DATE MAILED: 11/07/2005

Office Action Summary	Application No.	Applicant(s)
	10/748,790	NORDEEN, CLEVE E.
	Examiner	Art Unit
	Alfred Joseph Wujciak III	3632

This is the final Office Action for the serial number 10/748,790, MULTIPURPOSE CAMPING HOOK, filed on 12/30/03.

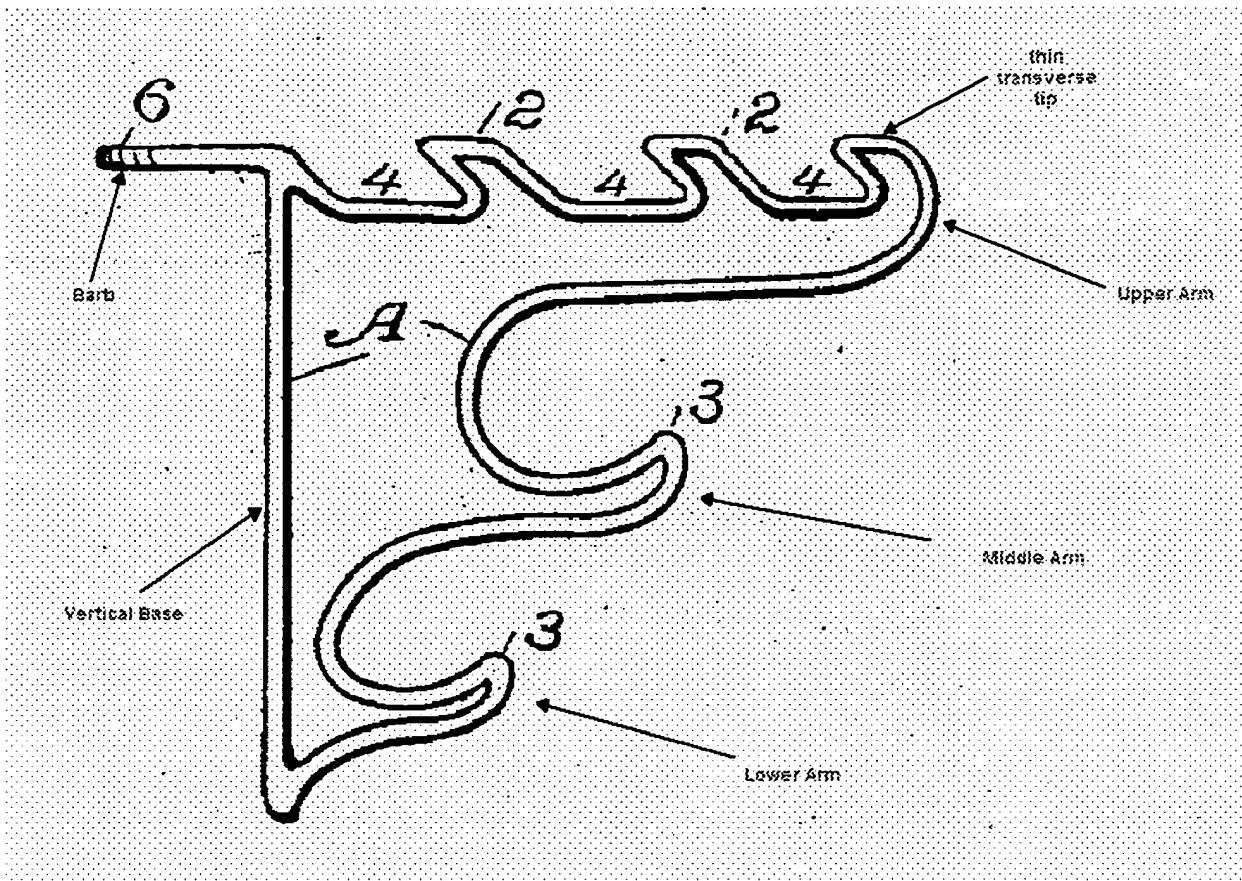
The applicant disagrees that the upper arm of Rush's invention comprising "thin transverse tip" since it is constructed as wire and having semicircular surface. See the drawing below for clarification and that the top part of the upper arm can function as a screwdriver because it is made of wire which will fit in the screw head (with slot in the top) which has ability of turning the screw.
